10.4 Other Features of Steam and Power Conversion

The information in this section of the reference ABWR DCD, including all subsections, tables, and figures is incorporated by reference with the following departures and supplements.

Figure 10.4-1 Main Condenser Evacuation System

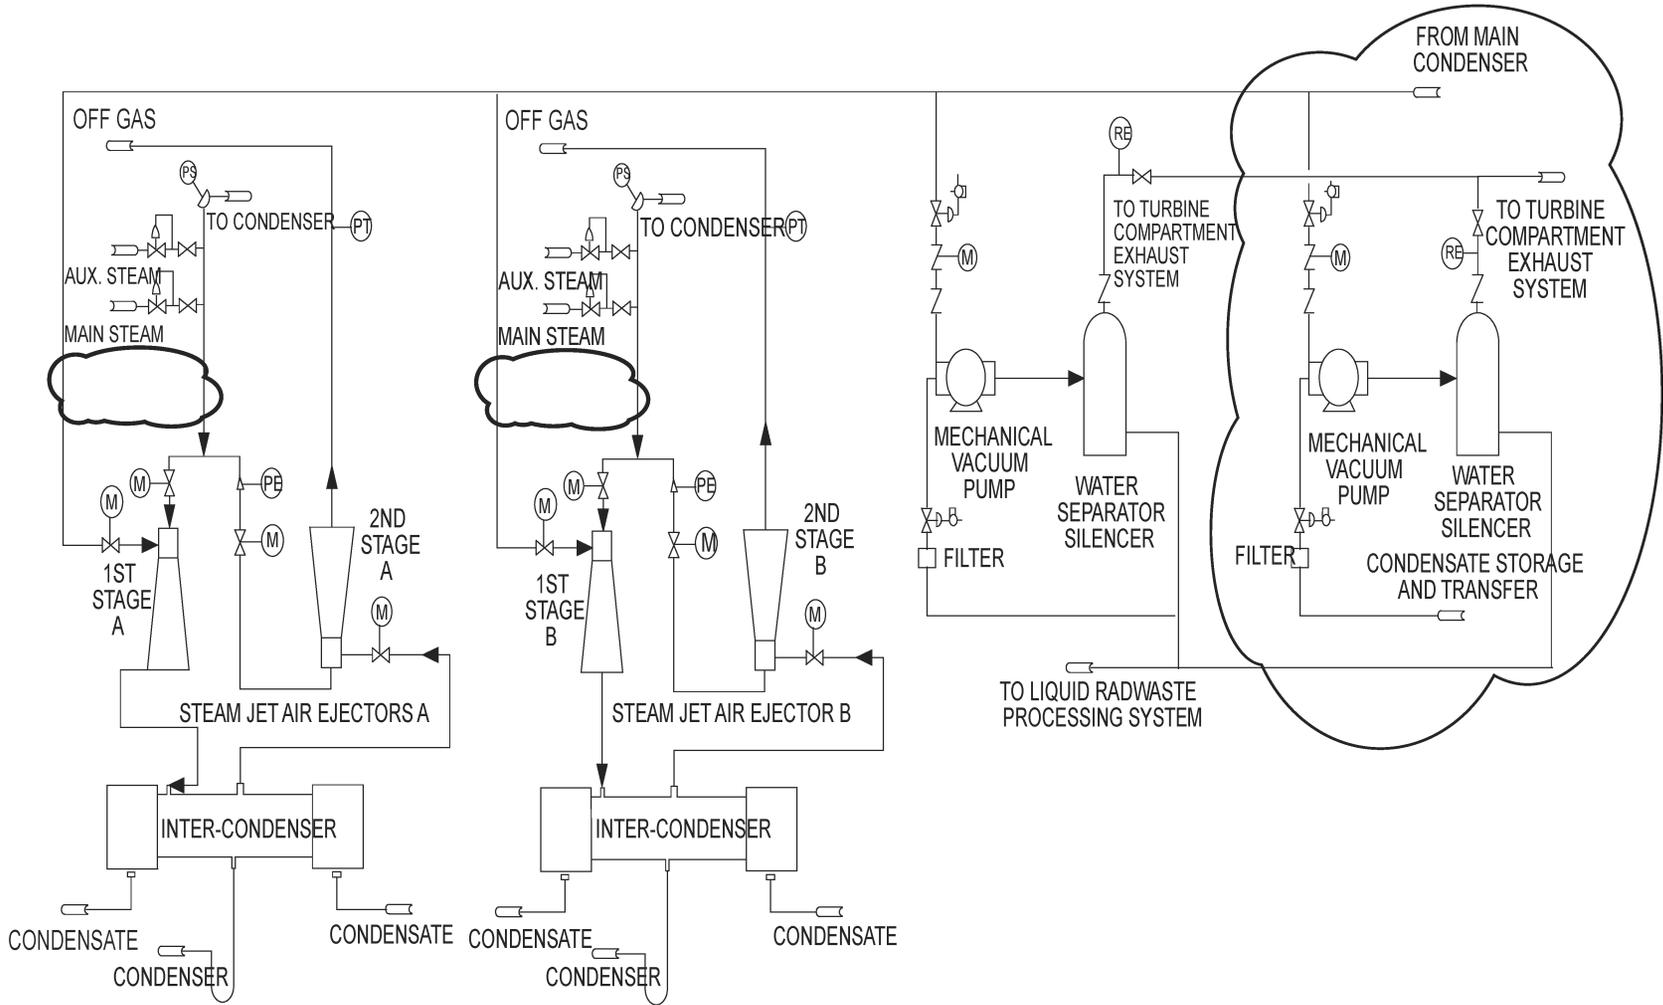
STP DEP 10.4-3

The MCES (figure 10.4-1) consists of two 100%-capacity, double stage, steam jet air ejector (SJAE) units (complete with ~~intercondenser~~ intercondensers) for power plant operation, and a ~~two, 100% mechanical vacuum pump~~ pumps for use during startup.

The last stage of the SJAE is a noncondensing stage. One SJAE unit is normally in operation and the other is on standby.

Figure 10.4-2 Turbine Gland Seal System

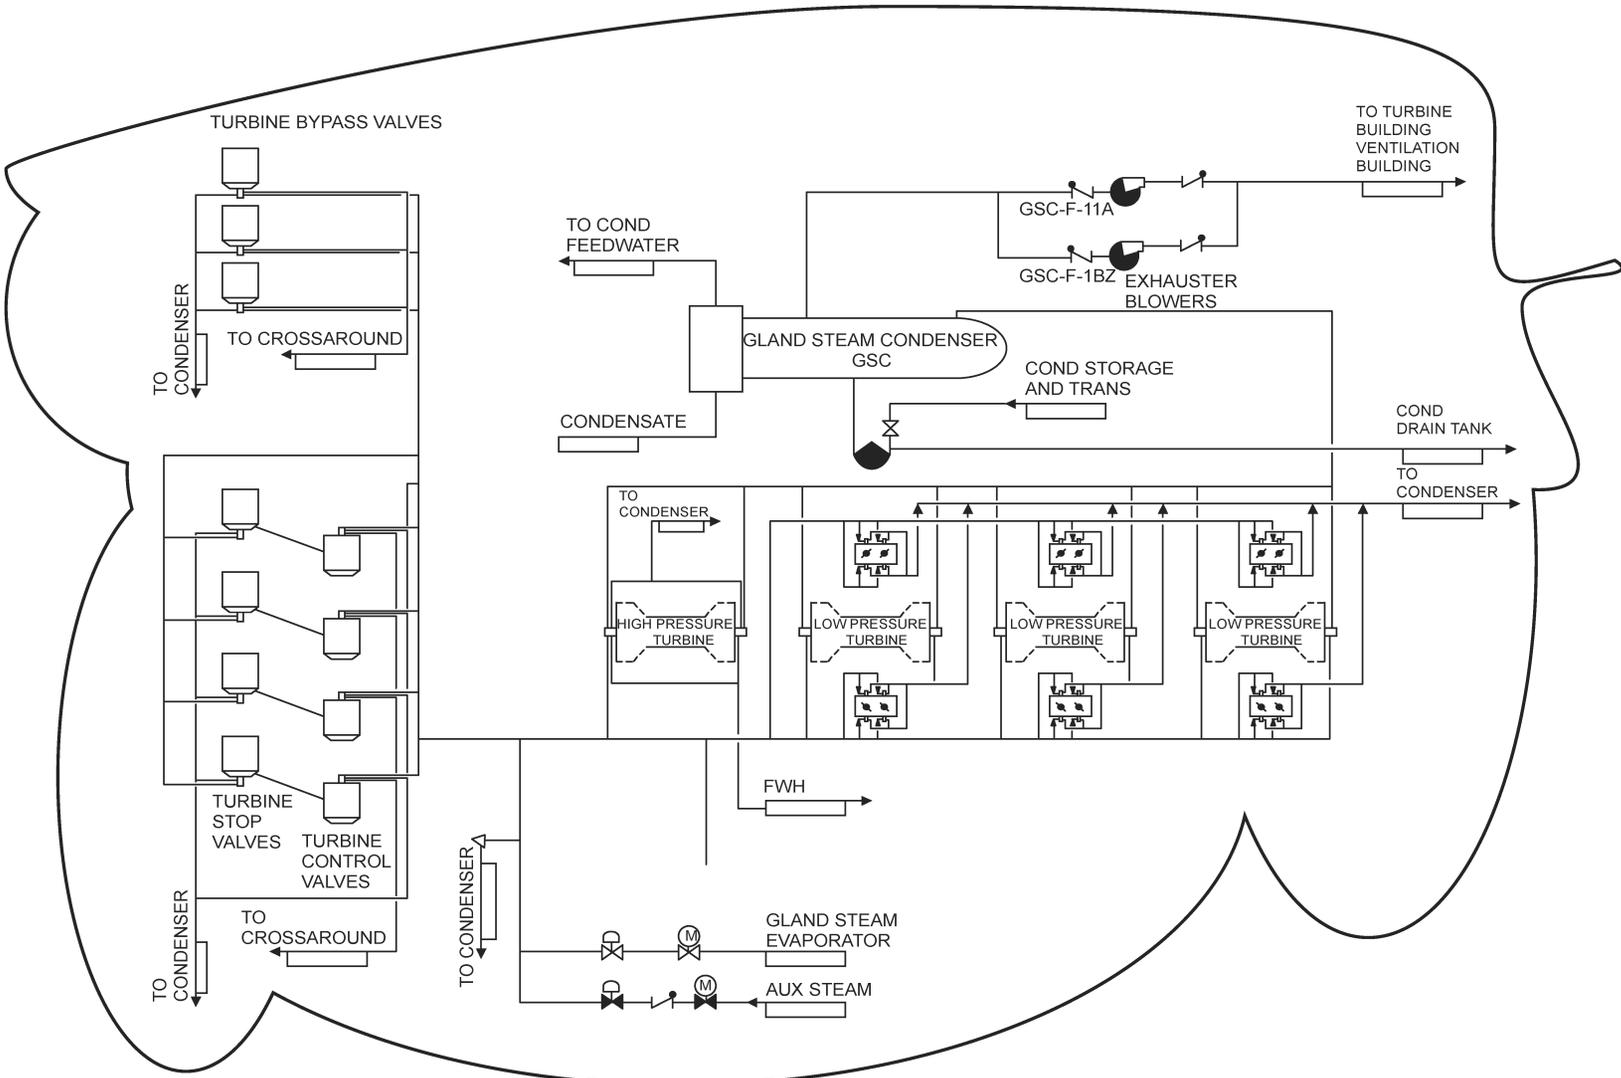
STD DEP 10.4-1

The turbine gland seal system is illustrated in Figure 10.4-2. The turbine gland seal system consists of a gland steam evaporator, sealing steam pressure regulator, sealing steam header, a gland steam condenser with two full-capacity exhausters blowers, and the associated piping, valves and instrumentation.

Figure 10.4-3 Circulating Water System

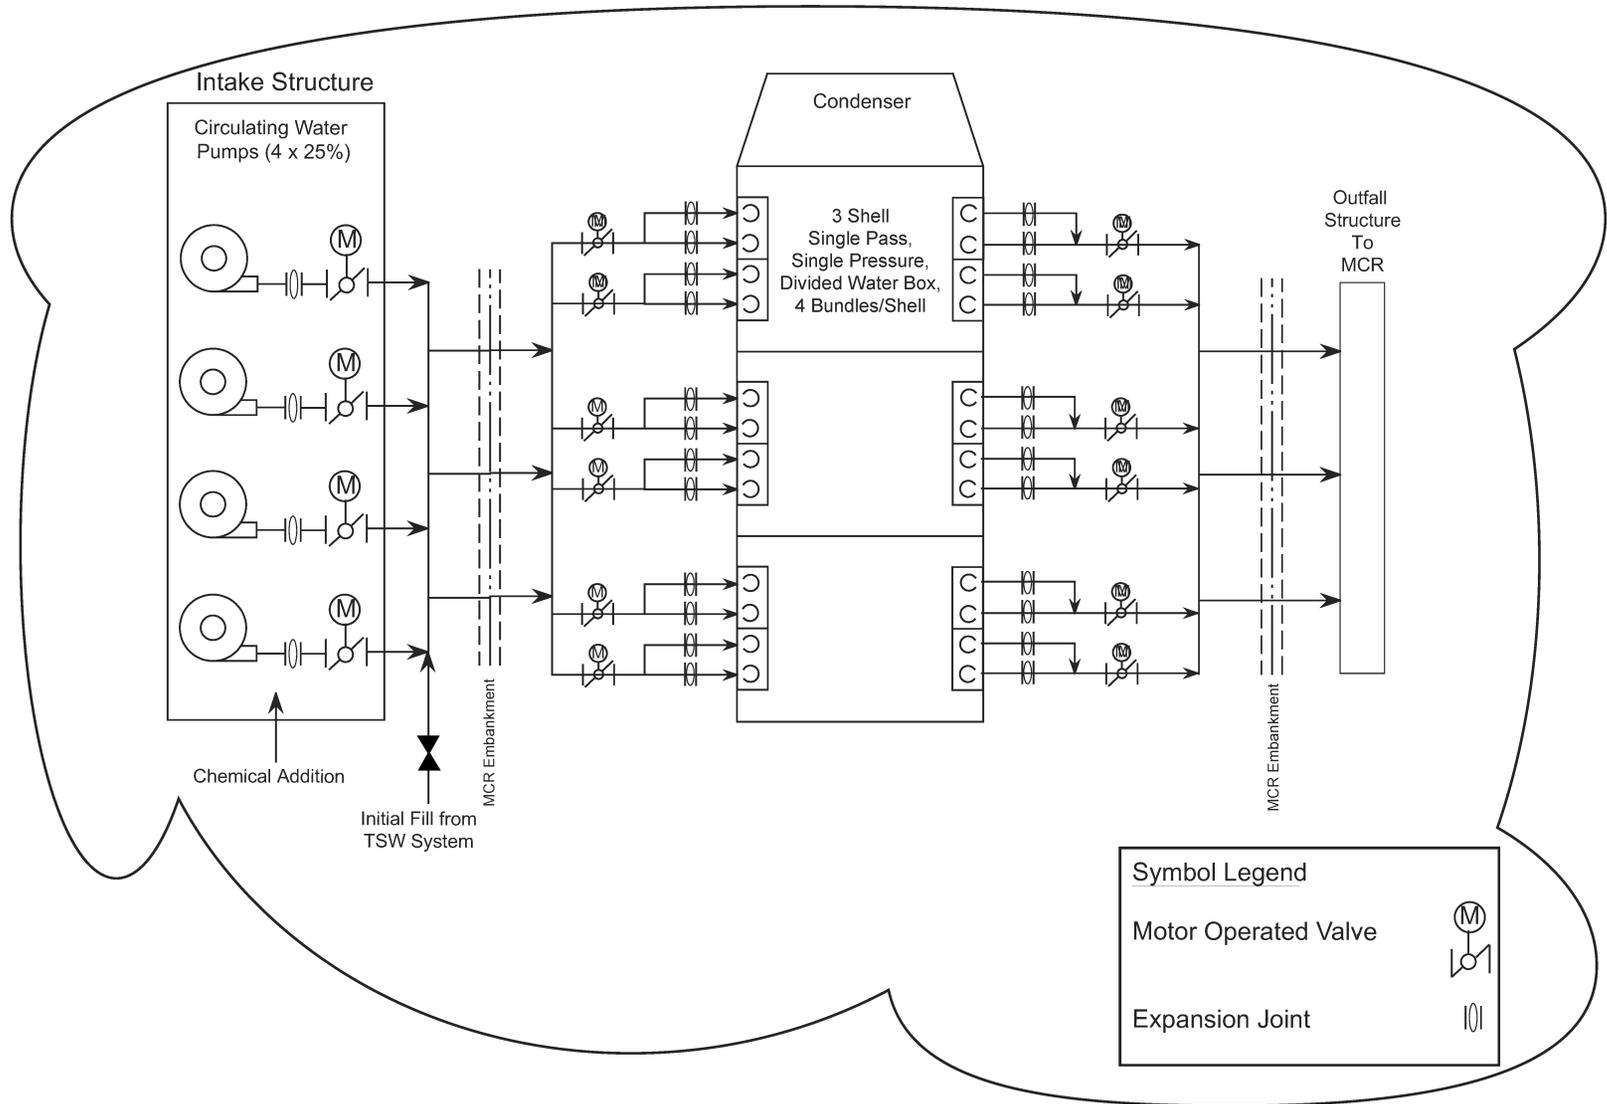
STP DEP 10.4-2

The Circulating Water System (Figure 10.4-3) consists of the following components: (1) ~~screen house intake structure and intake screens, pumps,~~(2) condenser water boxes and piping and valves, (3) tube side of the main condenser, (4) water box fill and drain subsystem, and (5) related support facilities such as for system water treatment, inventory blowdown and general maintenance.

The cooling water is circulated by ~~at least three~~ four 25% capacity fixed speed motor-driven pumps per unit.

Four 25% capacity fixed speed circulating water pumps per unit discharge into a common header shown in Figure 10.4-3. The discharge of each pump is fitted with a motor operated butterfly valve. The circulating water is pumped through the main condenser and back to the MCR via a discharge outfall at a nominal rate of 272,550 m³/h per unit. To provide capability for condenser waterbox isolation, isolation valves are located on the circulating water inlet and outlet lines.

Figure 10.4-4 Condensate Purification System

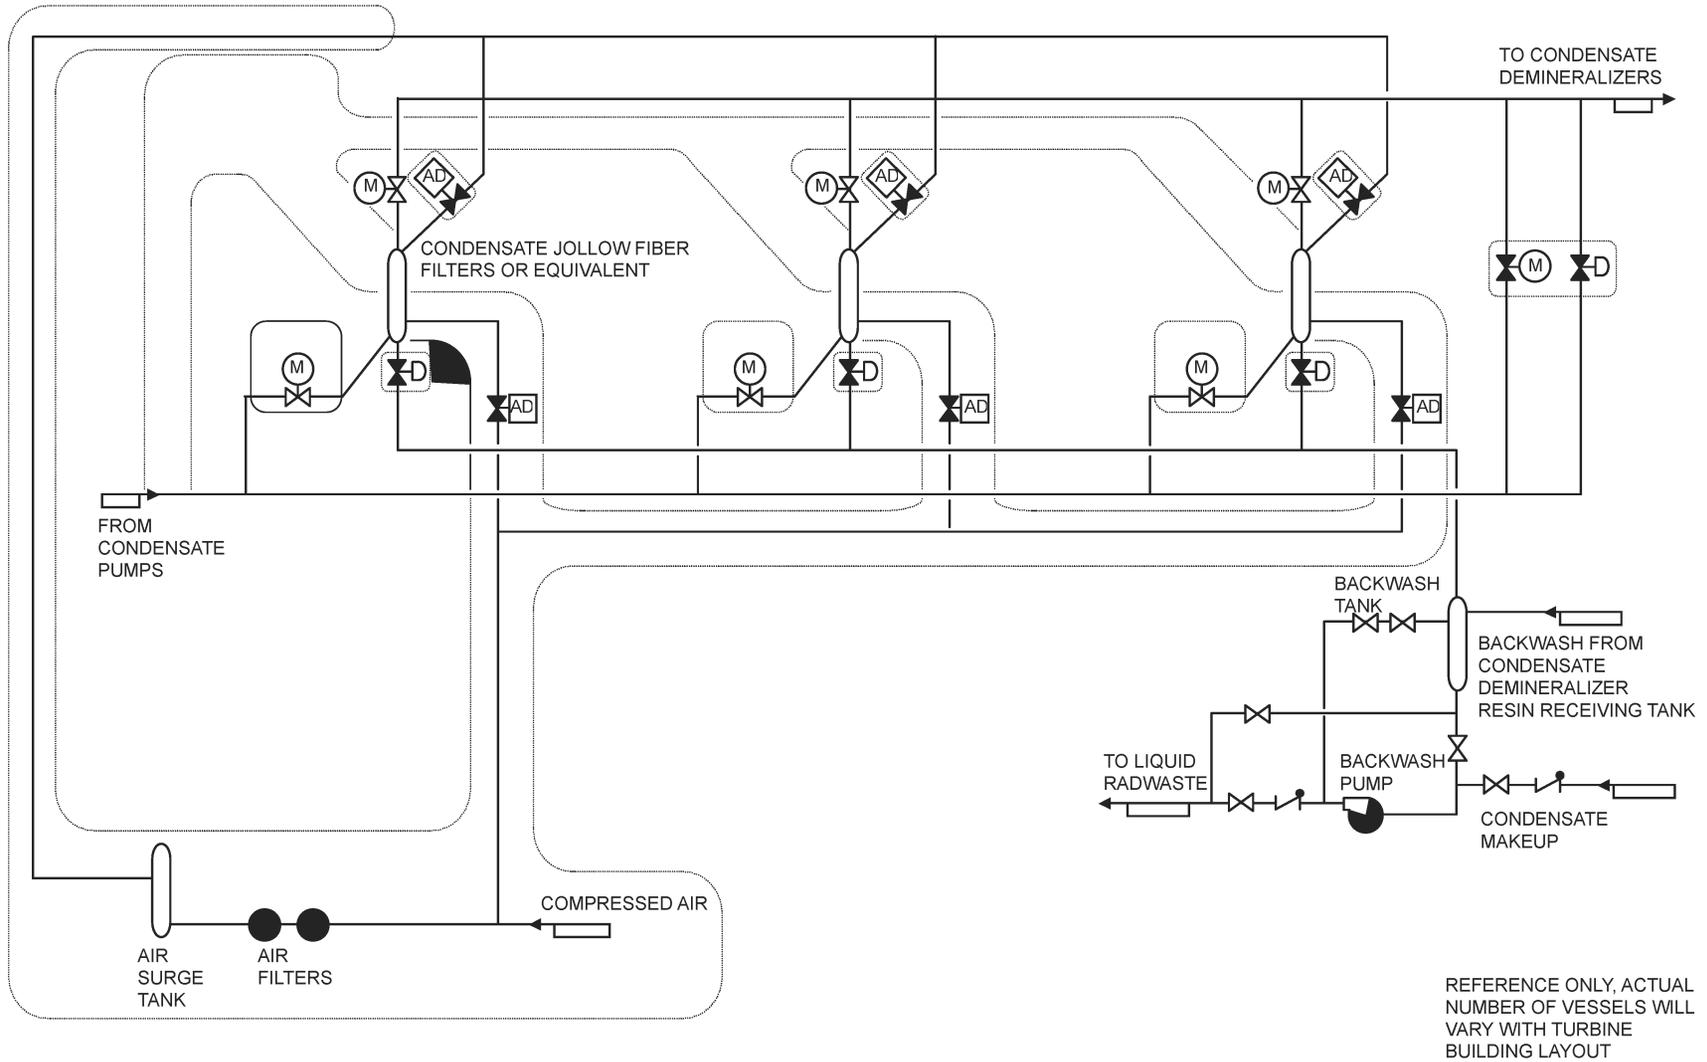
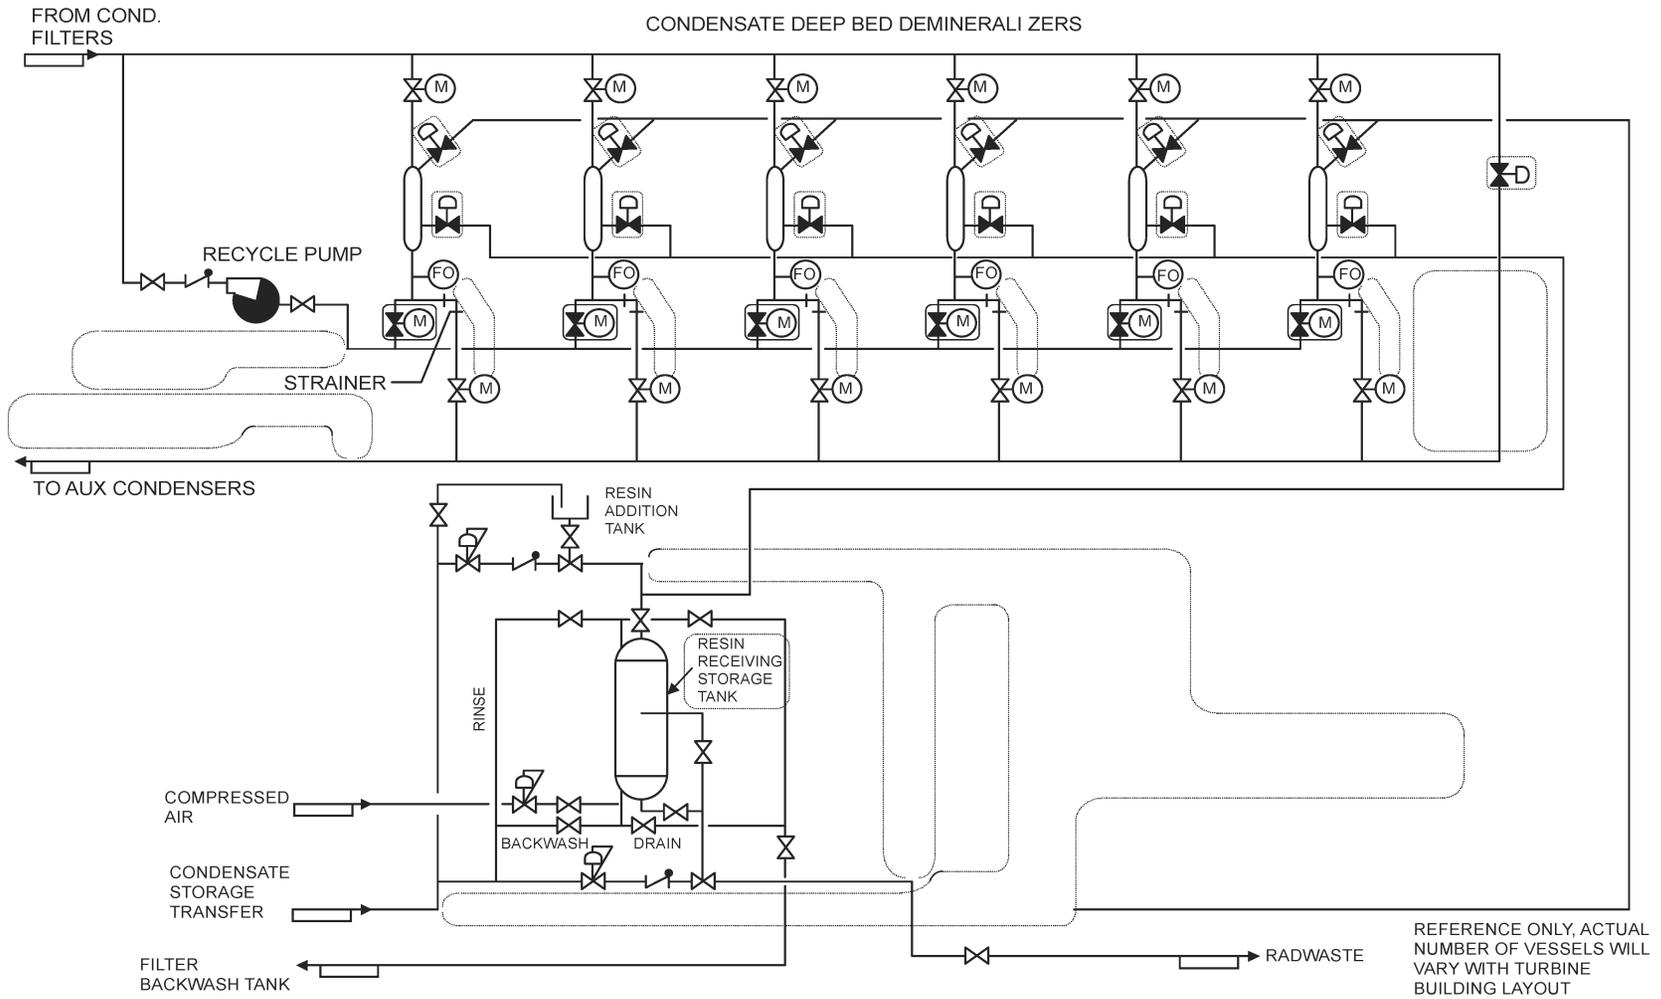
STP DEP 10.4-4

The Condensate Purification System (Figure 10.4-4) consists of at least three high efficiency filters arranged in parallel and operated in conjunction with a normally closed filter bypass. The CPS also includes at least six bead resin, mixed bed ion exchange demineralizer vessels arranged in parallel with ~~all six~~ normally ~~at least five~~ in operation ~~and one in standby~~. A strainer is installed downstream of each demineralizer vessel to preclude gross resin leakage into the power cycle in case of vessel underdrain failure, and to catch resin fine leakage as much as possible. The design basis for the CPS system will be to achieve the water quality effluent conditions defined in a water quality specification. The CPS components are located in the Turbine Building.

Provisions are included to permit air scrub cleaning and replacement of the ion exchange resin. Each of the demineralizer vessels has ~~fail-open~~ "as-is" inlet and outlet isolation valves which are remotely controlled from the local CPS control panel.
